## **IMPORTANT SAFETY RECALL**

**NHTSA Recall No. 23V-703**

**SN723**

SUBJECT: Pedestal Mounting Bolts

Figure 1. Area of unit to inspect pedestal to sub-base mounting bolts

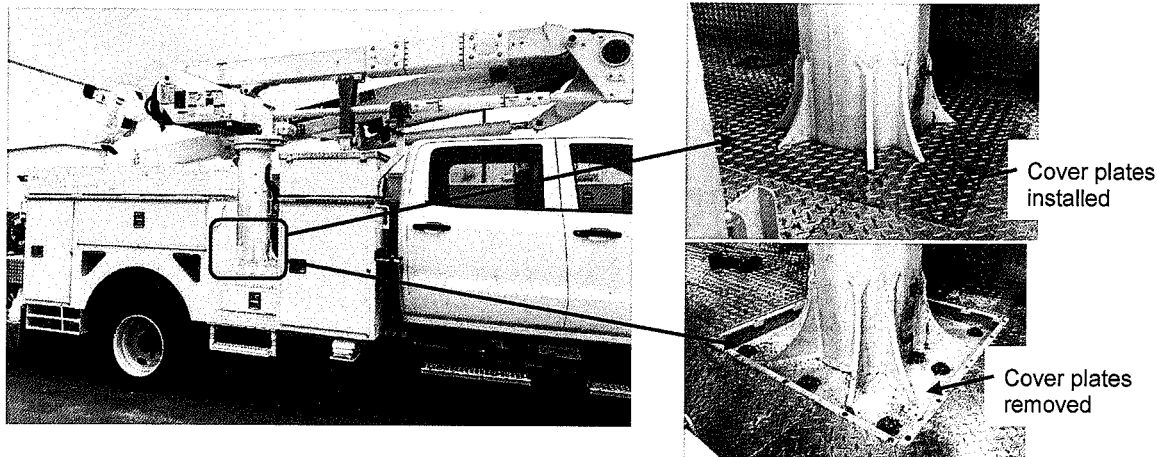
1. Immediately inform all users, operators, and supervisors that the pedestal to sub-base mounting bolts must be inspected before further use. Cover plates at the base of the pedestal may need to be removed to inspect the bolts, refer to Figure 1.

3. Inspect to determine if the pedestal to sub-base mounting bolts are loose.
  - a. The inspection involves a torque check on all pedestal to sub-base mounting bolts using a calibrated torque wrench.

- b. Any loose pedestal to sub-base mounting bolts are to be retorqued using a calibrated torque wrench. Grade 5 bolts are to be retorqued to 300 ft-lbs and grade 8 bolts to 460 ft-lbs.

- c. After retorquing all pedestal to sub-base mounting bolts, apply torque striping across the bolt head and washer to the bolting plate to aid in further visual inspections.
